RFP Title: Classical High School Campus Electrical Upgrades

Addendum #: 2

Addendum #2

Project: Classical High School 770 Westminster St., Providence, RI 02903

1 ED60

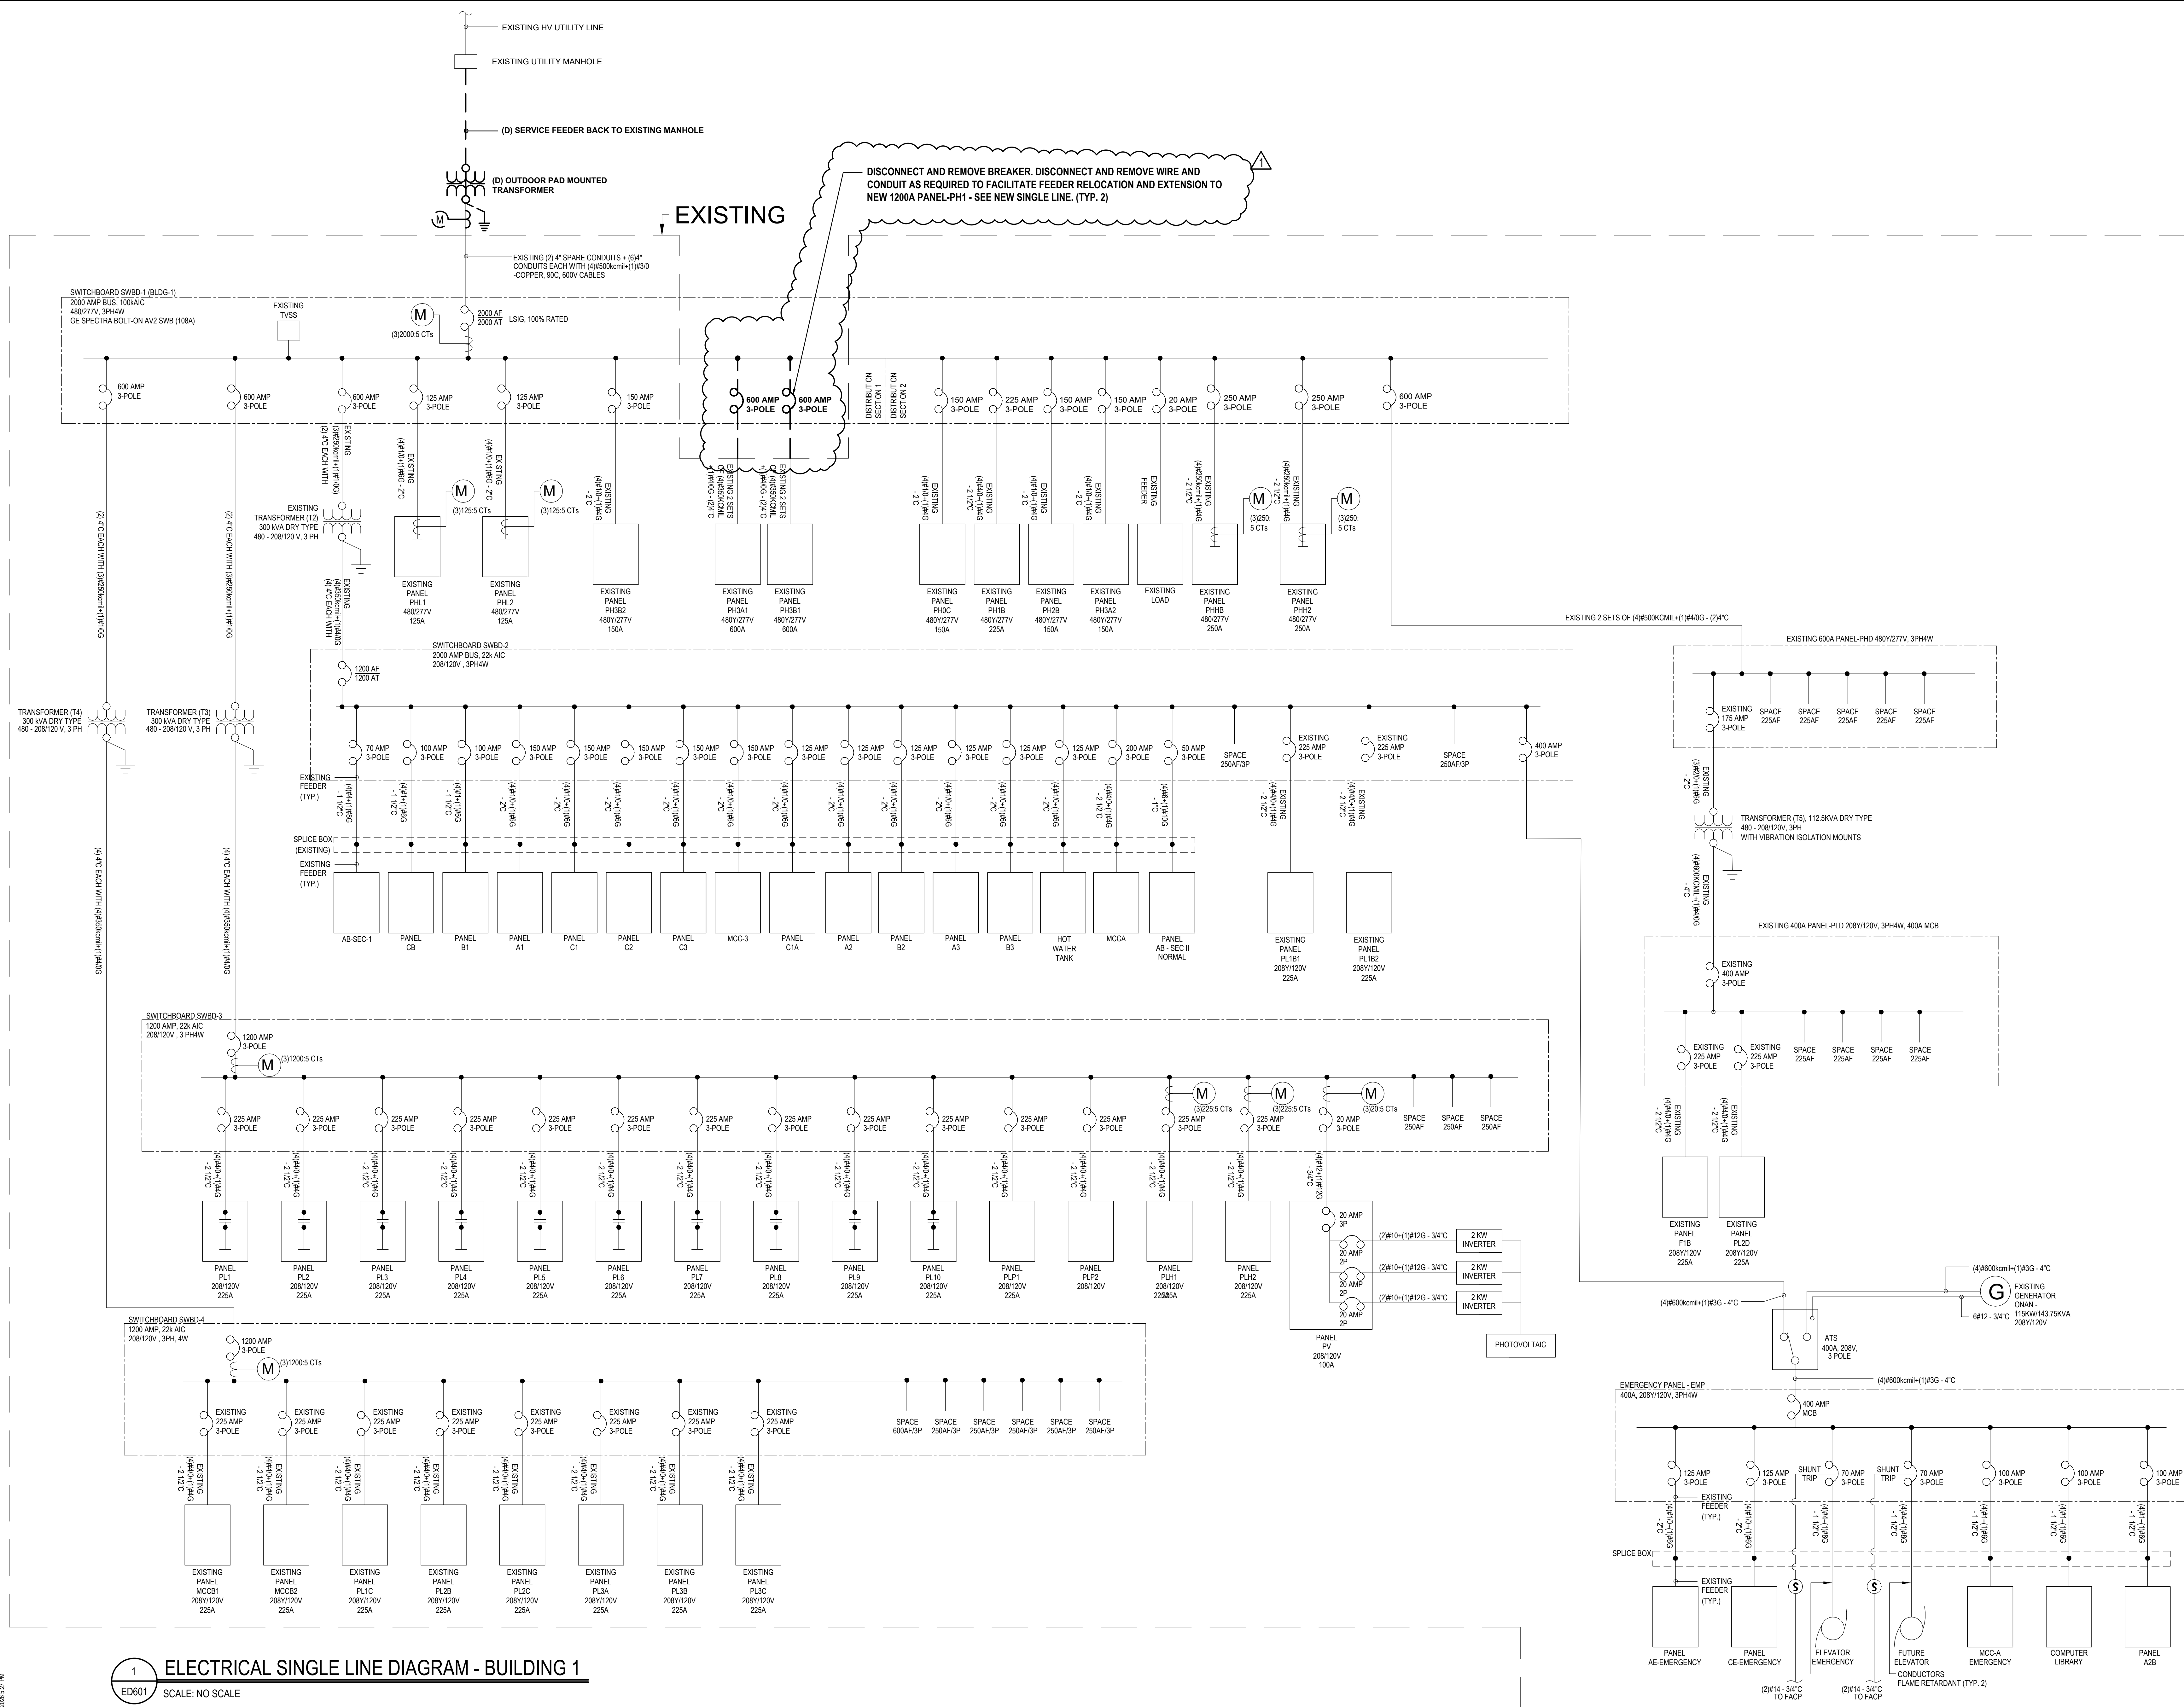
- a. Added this sheet.
 - b. Added the demolition of (2) 600A breakers from the main switchboard. Added to remove the associated feeders for extension and reconnection to the new 1200A panel.

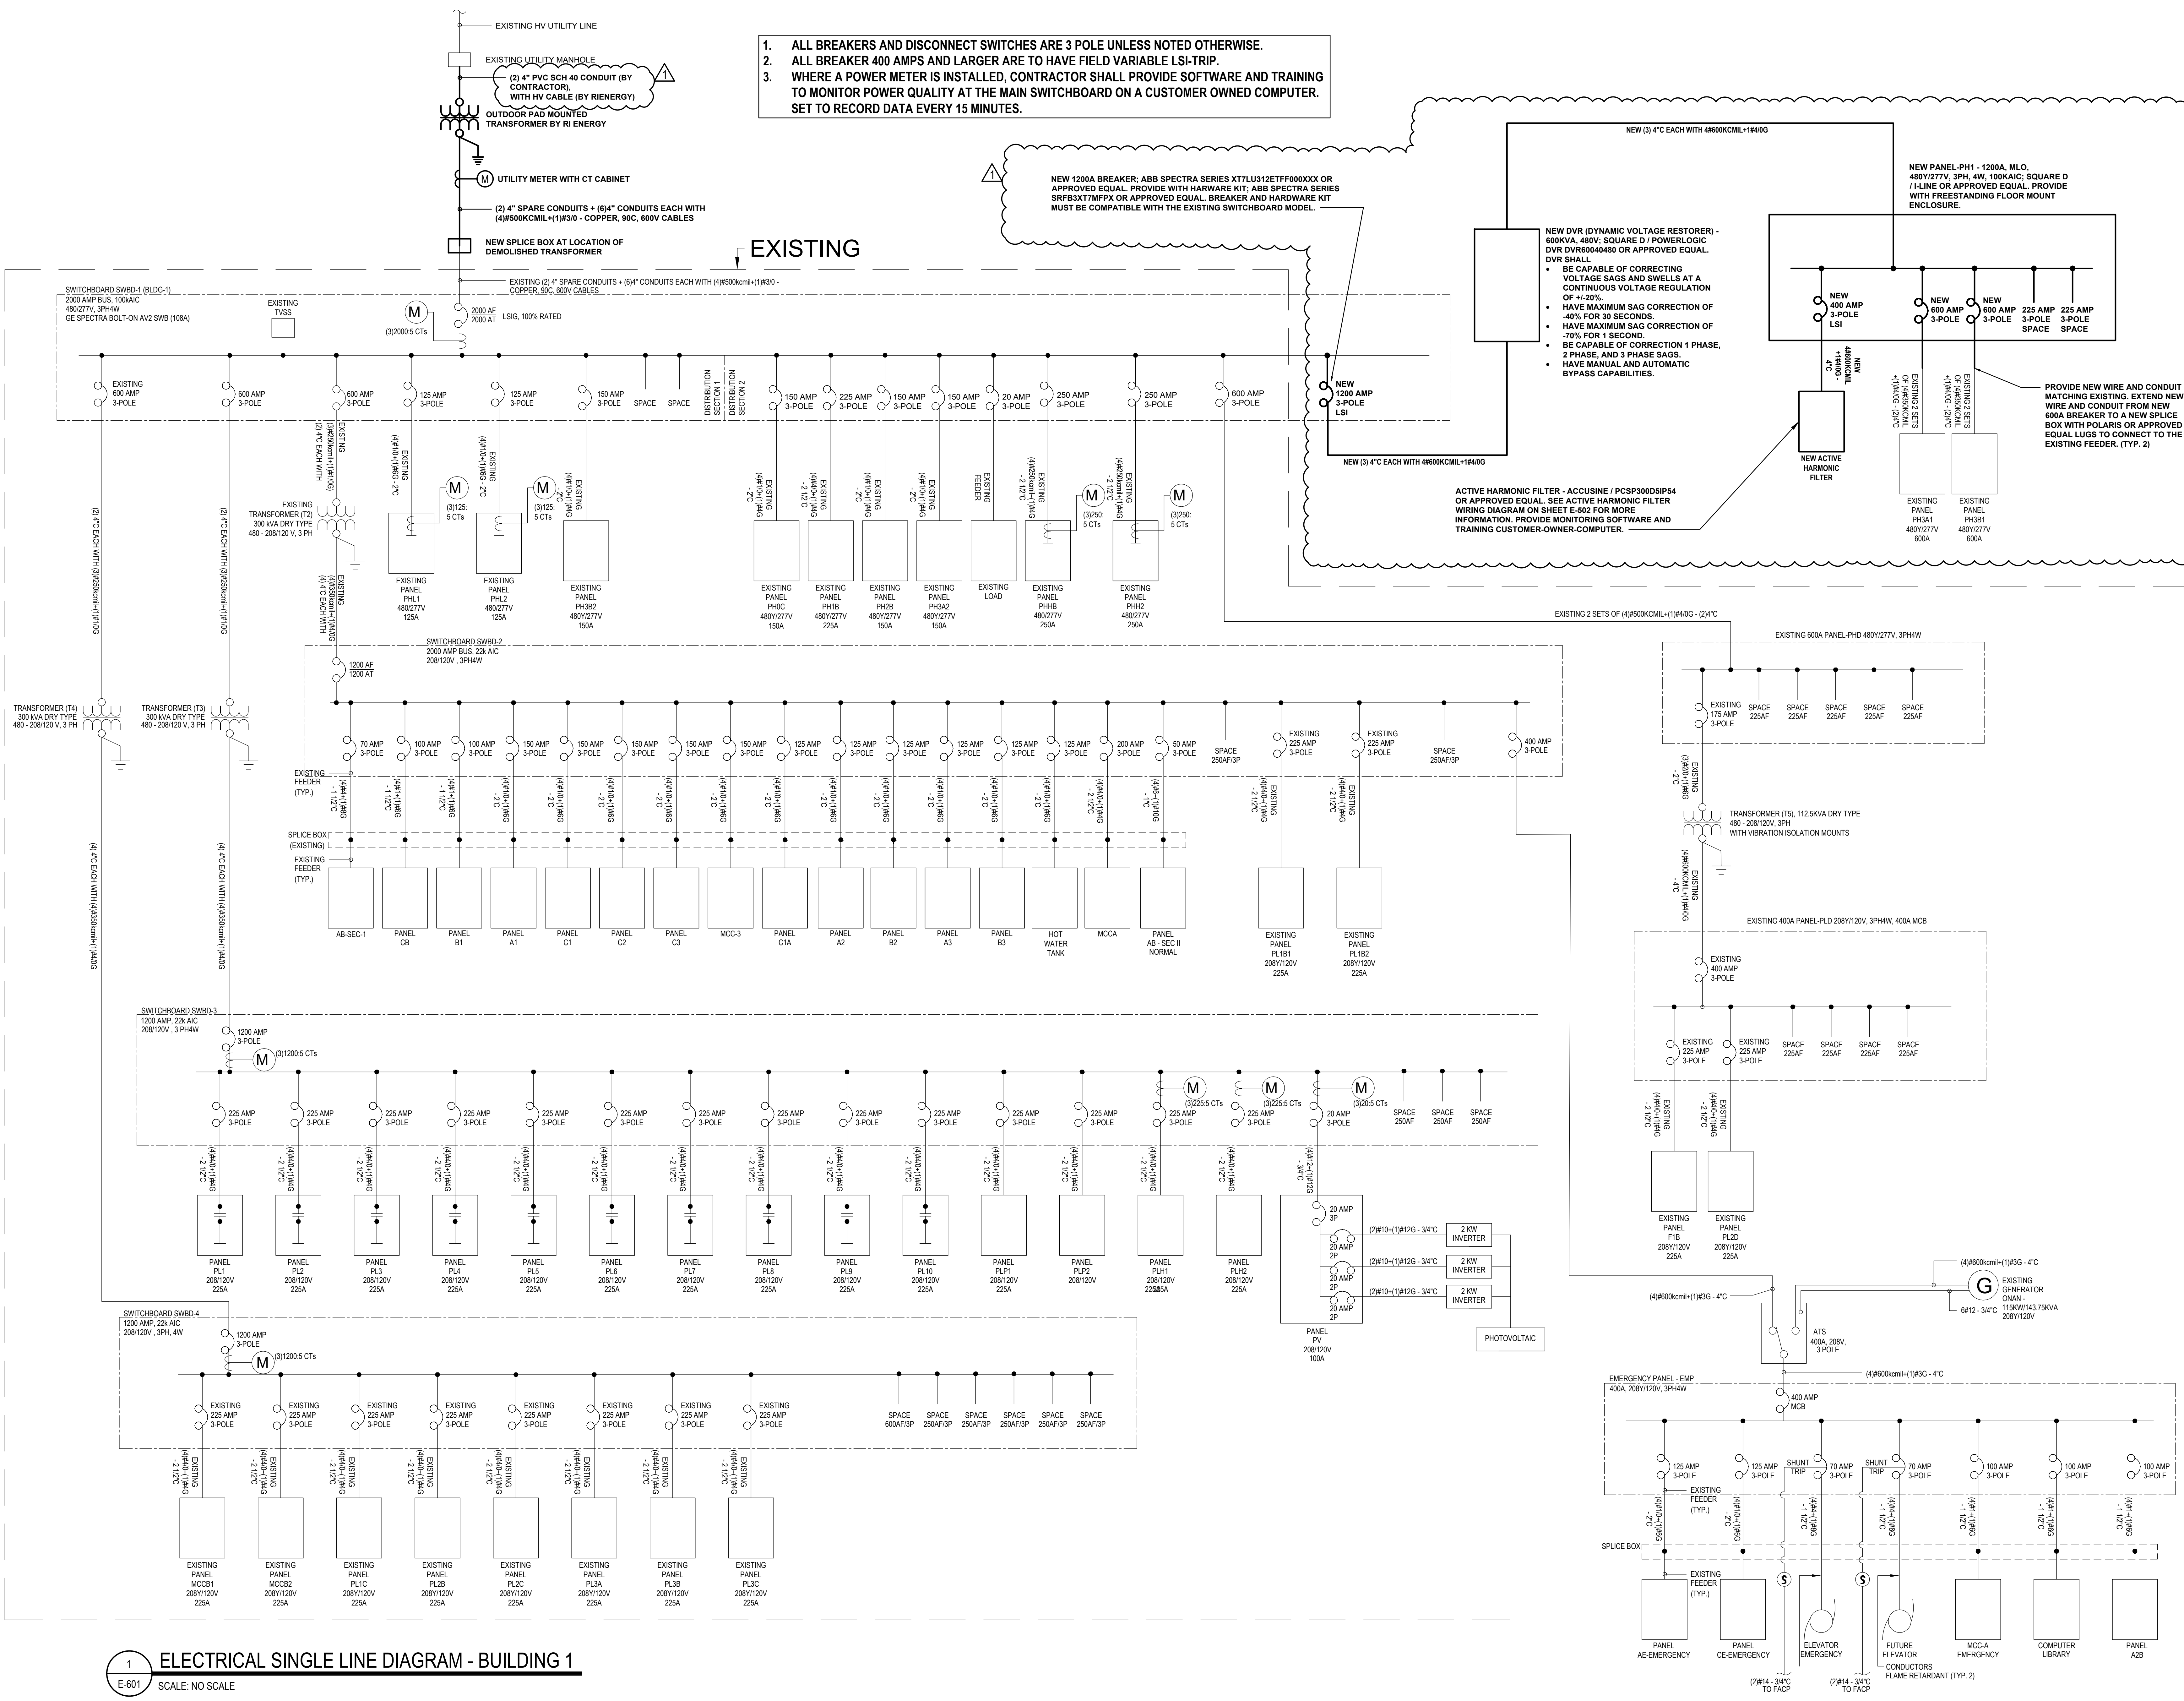
6. *Drawing E-601*
- a. Revised the feeder on the primary side of the utility transformer to clarify that conduit is by contractor and HV cabling is by RIEnergy.

- b. Added a DVR (dynamic voltage restorer). Added a 1200A breaker and hardware kit to the main switchboard. Added a feeder from the 1200A breaker to the DVR and from the DVR to a new 1200A panel. Added feeder extensions to reconnect panels PH3A1 and PH3B1 from the switchboard to the new 1200A panel.

- c. Moved the active harmonic filter from the existing switchboard to the new 1200A panel.
7. *Drawing E-602*
- a. Deleted the new splice box from the single line. (New switchgear manhole is still required, see site plan)
